Access Compliance Report

Public Rights-of-Way

Intersection ID: 50464	Main Street: LENOX_POINTE_DR	Cross Street: SANDY_PORTER_RD	Location: NE
ADA ID: 4592B97A9017	Ramp Type: BlendTrans1	Initial Pass/Fail: Pass	Overall Compliance: No
Severity Score: 5			
Codes/Mitigation Info/Possible Solution		Field Measurements/Component Compliance

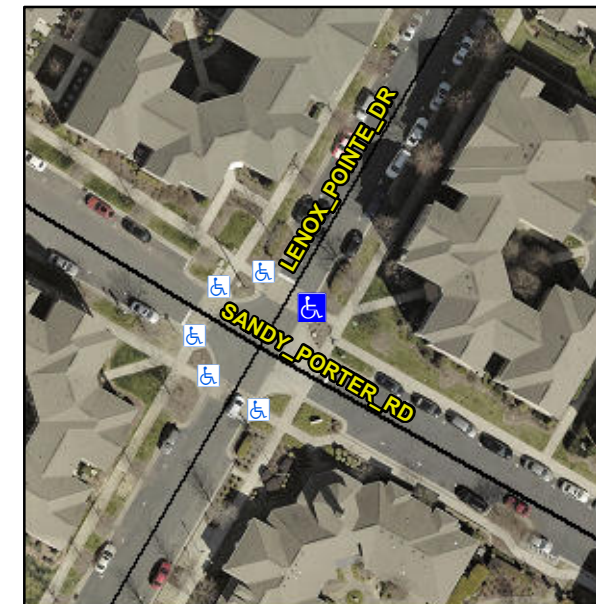
XWALK PAVERS, NO PAINT

R304.2.2-Perp, R304.3.2-Para, R305.2, R304.5.4

Compliance	Description	Data	Compliance	Description	Data
N/A	Ramp Length (in)	70.0	Yes	BlendTrans Slope (%)	5.0
Yes	Ramp Width (in)	48.0	Yes	BlendTrans XSlope (%)	1.2
N/A	Flare Type LT	Sloped	N/A	Flare Type RT	Sloped
N/A	Flare Slope LT (%)	5.5	N/A	Flare Slope RT (%)	7.9
N/A	Flare Traversable LT?	No	N/A	Flare Traversable RT?	No
Yes	Landing Length (in)	54.0	Yes	DWS Provided?	Yes
Yes	Landing Width (in)	60.0	Yes	DWS Contrast?	Yes
No	Landing Slope (%)	2.3	Yes	DWS Length (in)	24.0
Yes	Landing X Slope (%)	0.2	Yes	DWS Full Width?	Yes
N/A	Landing Curb? (Y/N)	No	No	DWS Offset (in)	5.0
N/A	Shared Landing?	No			
Yes	Gutter Ponding?	No	No	Gutter Slope (%)	6.5
Yes	Gutter Lip Ht (in)	0.0	Yes	Gutter X Slope (%)	1.5
N/A	Painted X Walk1?	Yes	N/A	Painted X Walk2?	N/A
	X Walk 1 Direction	To W		X Walk 2 Direction	N/A
	X Walk 1 Width (in)	144.0		X Walk 2 Width (in)	N/A
	X Walk 1 Slope (%)	0.9		X Walk 2 Slope (%)	N/A
	X Walk 1 X Slope (%)	1.6		X Walk 2 X Slope (%)	N/A

Yes	Ramp inside XWalk1?	Yes	N/A	Ramp inside XWalk2?	N/A
	Road Slope (%)	1.6		Clear Space?	Yes
	Road X Slope (%)	0.9	N/A	Clear Space to XWalk (in)	N/A
Yes	Any Obstructions?	No	Yes	Storm Grate/Utility Hazard?	No
	Obstruction Type			Storm Grate/Utility Type	
		N/A			N/A
			Yes	Surface Condition? (G/P)	Good
			Yes	Curb Slope (%)	5.0

Remove & Replace Curb Ramp With Two New Directional Ramps or Equivalent. Remove & Replace Gutter.
